MFN 08-202

**Subject: Response to Request for Additional Information Letter No. 104
Related to the ESBWR Design Certification – Safety Analyses –
RAI Number 15.3-34**

**Response to Portion of NRC Request for
Additional Information Letter No. 104
Related to ESBWR Design Certification Application**

RAI Number 15.3-34

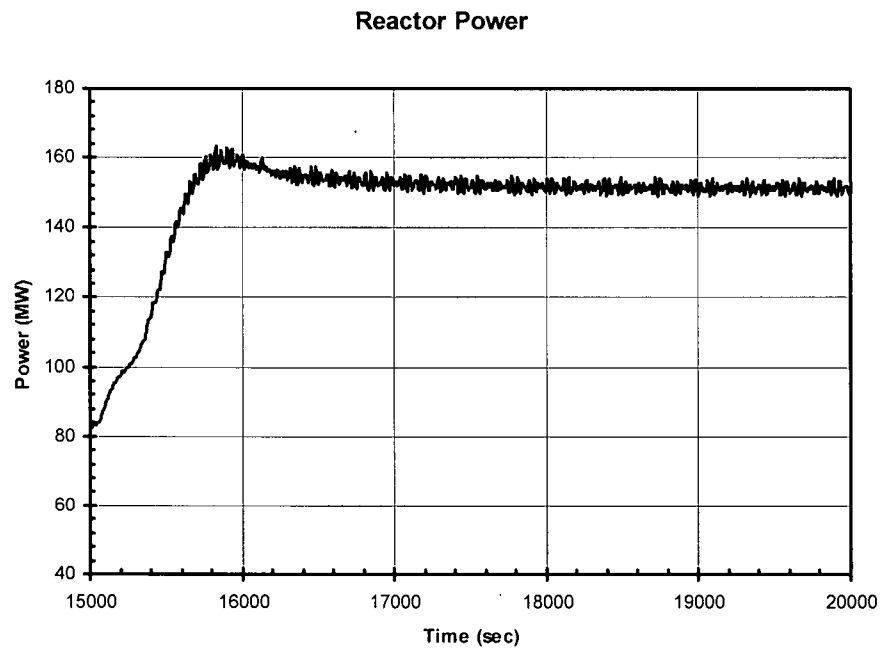
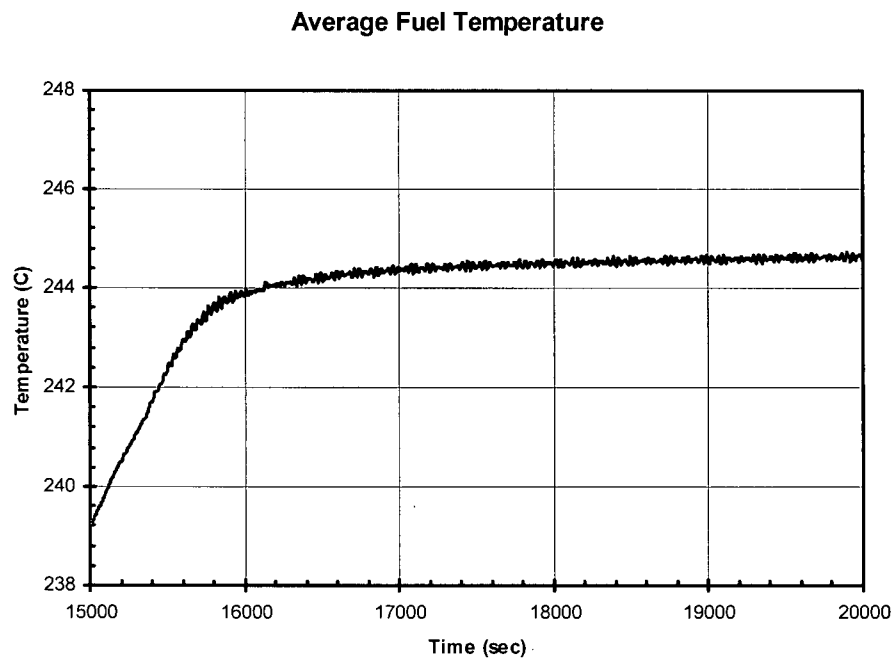
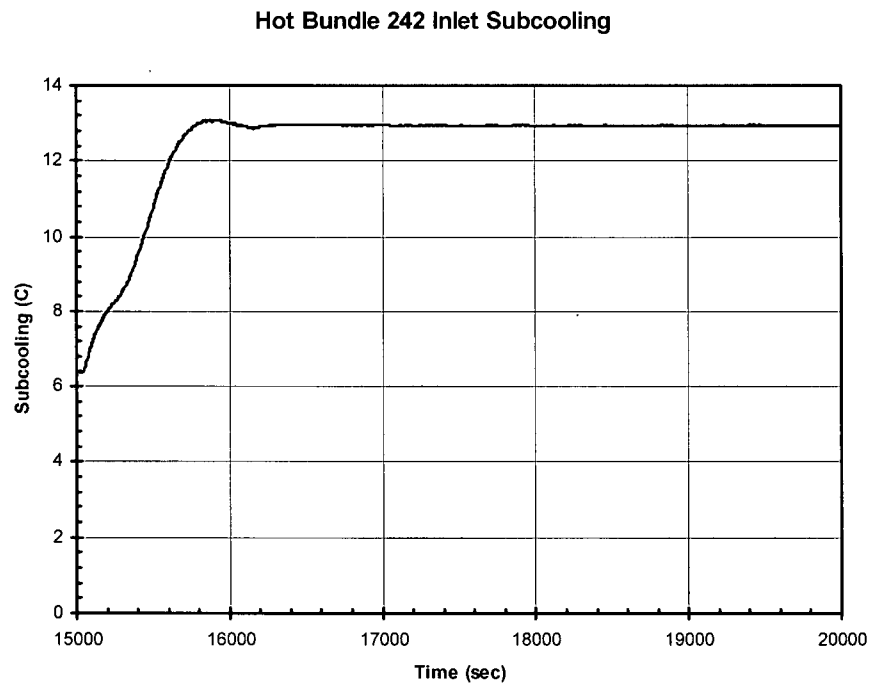
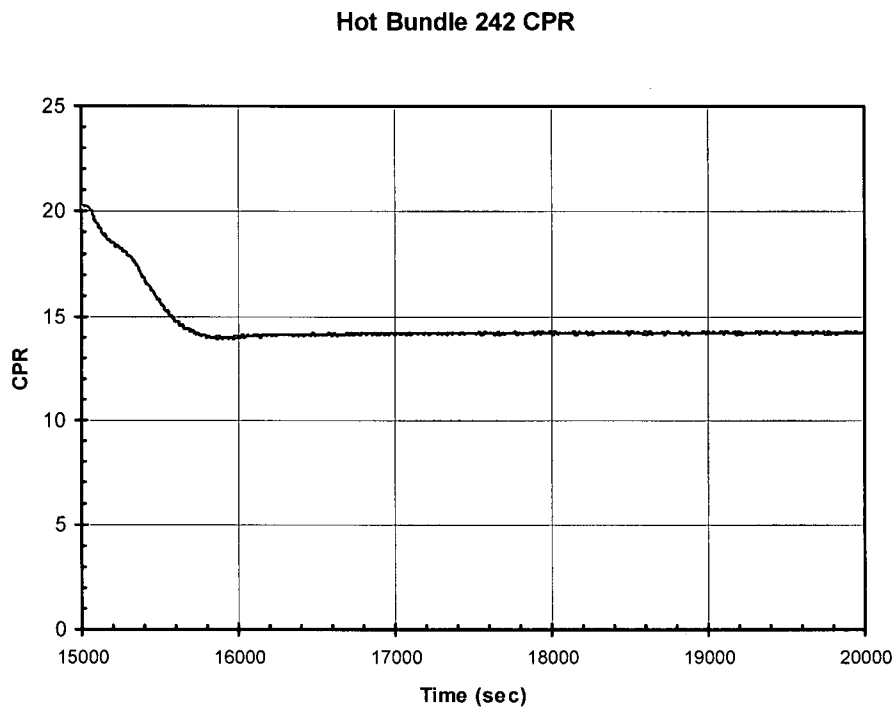
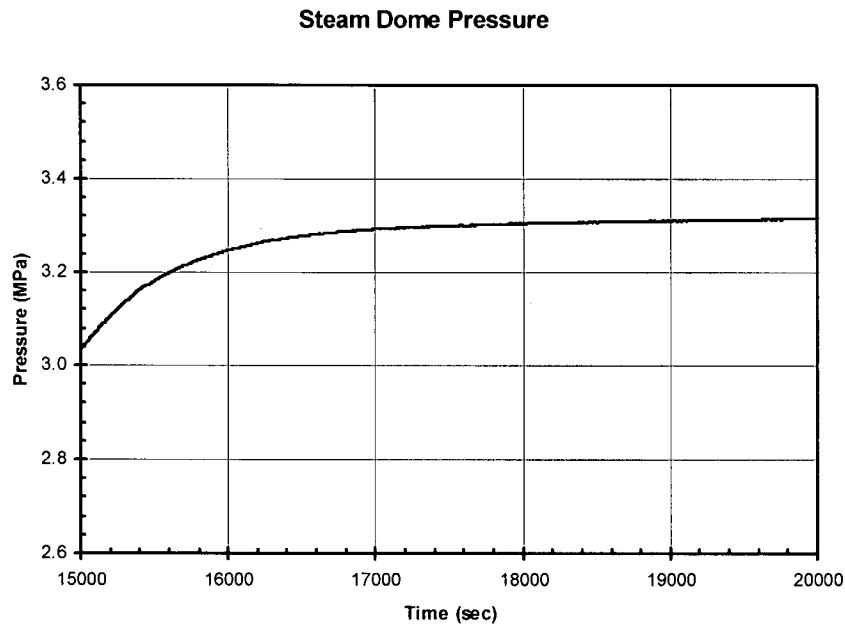
Regarding the inadvertent shutdown cooling function operation event, DCD Tier 2, Rev. 3, Section 15.3.12 states that: "the increased subcooling caused by misoperation of the RWCU/SDC shutdown cooling mode could result in a slow power increase due to the reactivity insertion. During power operation the reactor settles in a new steady state. During startup or shutdown, this power rise is terminated by a flux scram before fuel thermal limits are approached. Therefore, only a qualitative description is provided here and this event does not have to be analyzed for a specific core configuration."

Please quantify the range of expected temperature limits and the resulting reactivity and reactivity-rate resulting from misoperation of the RWCU/SDC shutdown cooling mode to justify the statement that the thermal limits will not be violated.

A TRACG simulation of inadvertent starting Reactor Water Cleanup (RWCU)/Shutdown Cooling (SDC) shutdown cooling during startup has been performed using conservative bounding values, yielding more than twice the rated heat removal capacity of 55.4 MWt (Table 5.4-3 in Reference 1). Figure 1 shows that starting the RWCU/SDC shutdown cooling results in a gradual power increase from a typical startup power of 85 MWt or 1.9% of rated thermal power (Section 4D.2.2.3 in Reference 2) to a new stable level of 150 MWt or 3.3% of rated thermal power over a period of 800 seconds. Figure 2 shows the core average fuel temperature increased by approximately 5.5 °C. Figure 3 shows the CPR of the hottest bundle, which decreases to 14 from the initial value of 20. Figure 4 shows the inlet subcooling of the hottest bundle increased by about 6.5°C. Figure 5 shows the steam dome pressure increased to 3.3 MPa from 3.04 MPa.

The TRACG simulation results confirm that the increased subcooling caused by misoperation of the RWCU/SDC shutdown cooling during startup results in a slow power increase due to the moderator reactivity insertion. The power increase is limited by the fuel-temperature reactivity feedback and stays well below the high flux scram setpoint of 675 MWt or 15% of rated thermal power for startup (Table 3.3.1.4-1 in Reference 3). The MCPR and fuel thermal limits are never challenged over the course of this transient.
